ATTACHMENT I TO NL-02-155

ANALYSIS OF PROPOSED
TECHNICAL SPECIFICATION CHANGE REGARDING
INCREASE OF LICENSED THERMAL POWER, 1.4%

ENTERGY NUCLEAR OPERATIONS, INC.
INDIAN POINT NUCLEAR GENERATING UNIT NO. 2
DOCKET NO. 50-247

Figure 2.1-1
Reactor Core Safety Limit – Four Loops in Operation

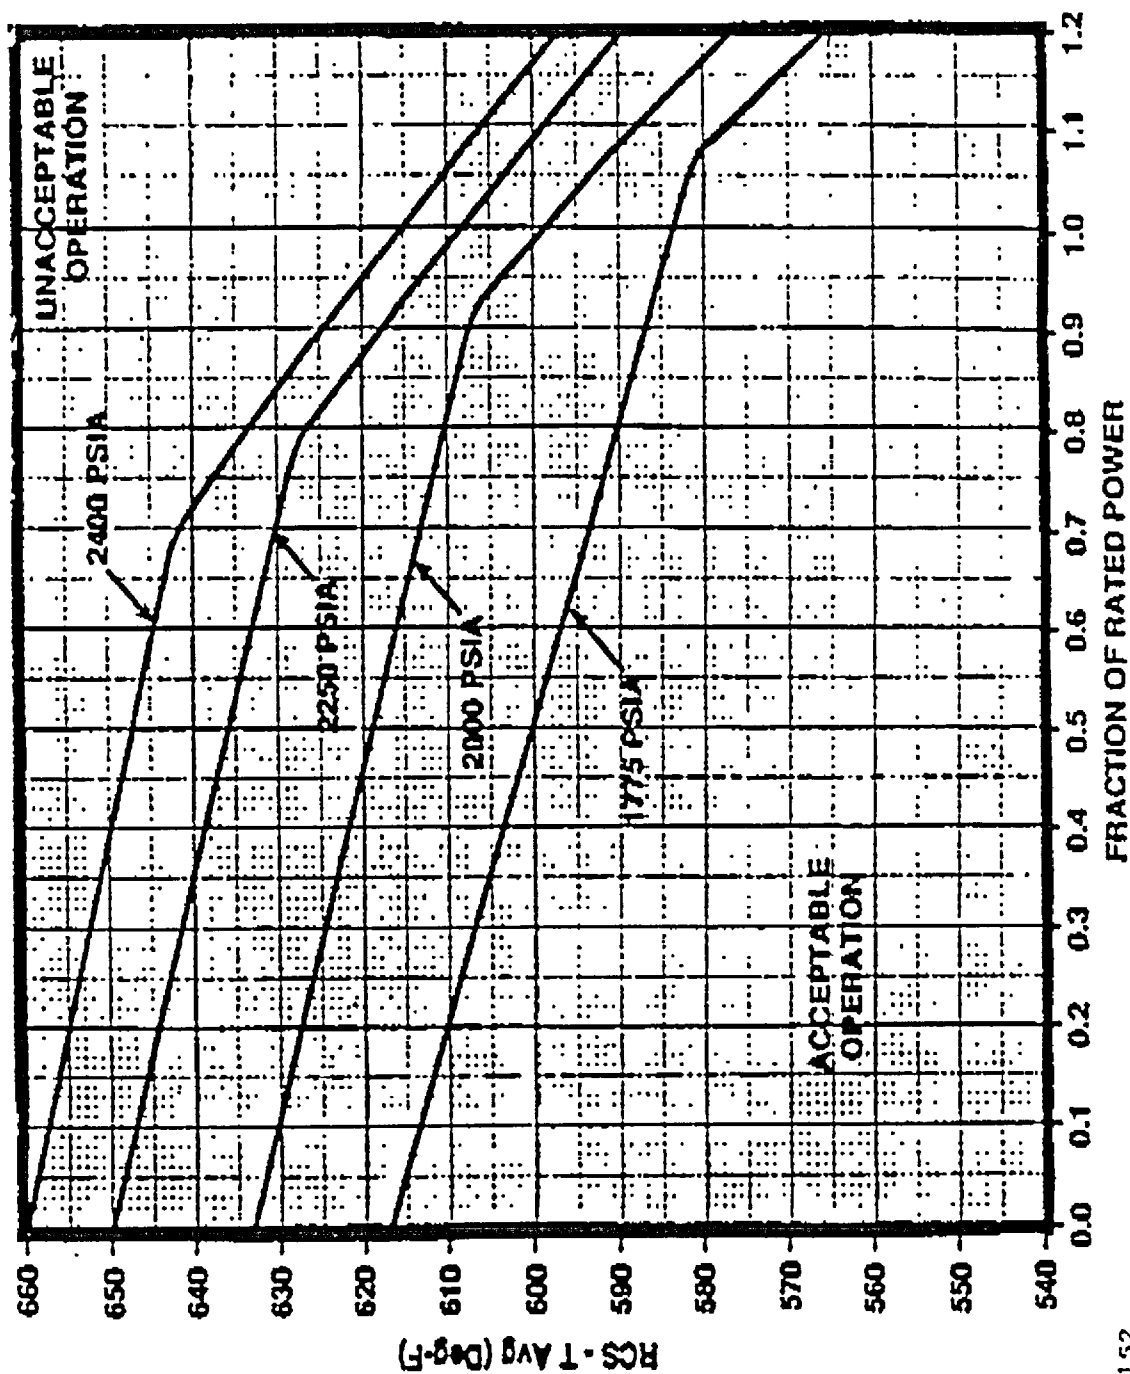
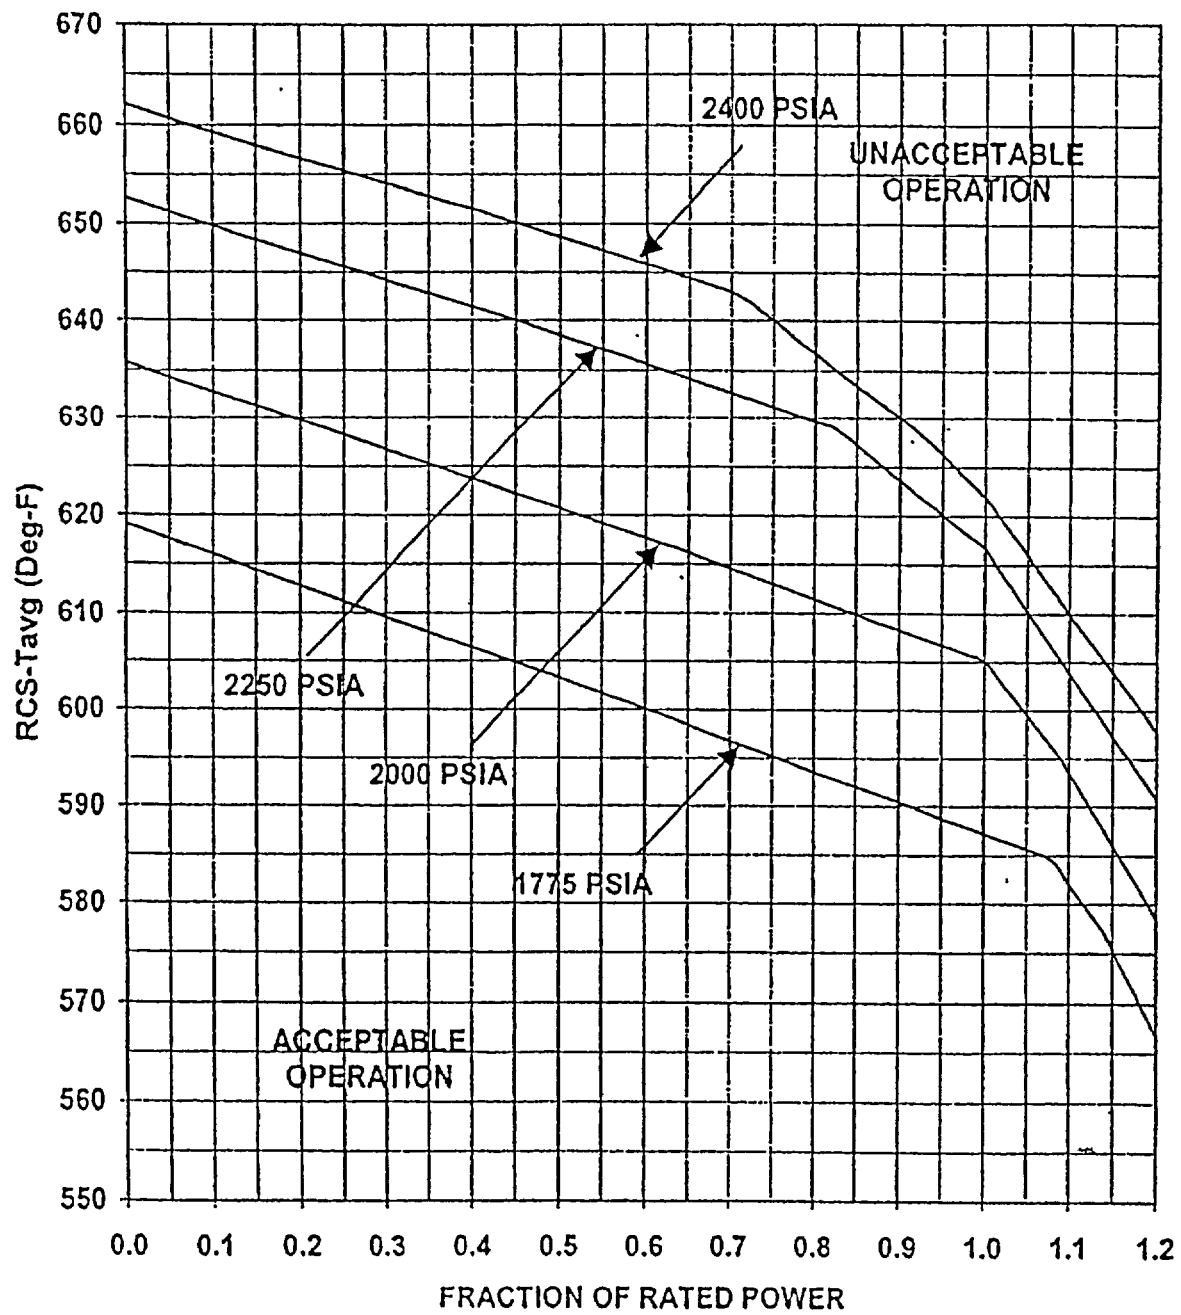
- c. Technical Specification Figure 2.1-1, "Reactor Core Safety Limit – Four Loops in Operation," will be replaced with a new figure updated to reflect the new maximum power level.

Delete this figure and replace with figure on next page.
